# Product Change Notification

Date Issued :	June 11, 2024	PCN Number :	515347
Reason for Change :	Manufacturing Process Change (Molex)		
Description of Change :	This notification is to inform you about manufacturing process change for the part/s listed in this notice is changing. No changes will be made to product as part of this change.		
Assessment of Change :	Supplier Qualification Test Report/s		
Planned Implementation Date :	December 11, 2024		
Customer Sample Availability Date:	June 20, 2024		
Last date to request Samples by Customer :	June 20, 2024		
Please note if Samples are not requested as per Customer Samples Request date, it may take additional 4-6 weeks to arrange Samples.			
Traceability Code Markings / Date :	Date code

Before Picture

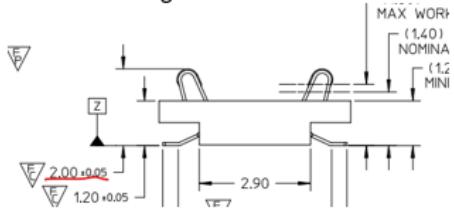
- Change the solder tail dimension

Before change:

E drawing 2.0+/-0.05

SD drawing

0.02+/-0.05

After change:

E drawing 2.0+0.11/-0.05

SD drawing

0.02+0.08/-0.02
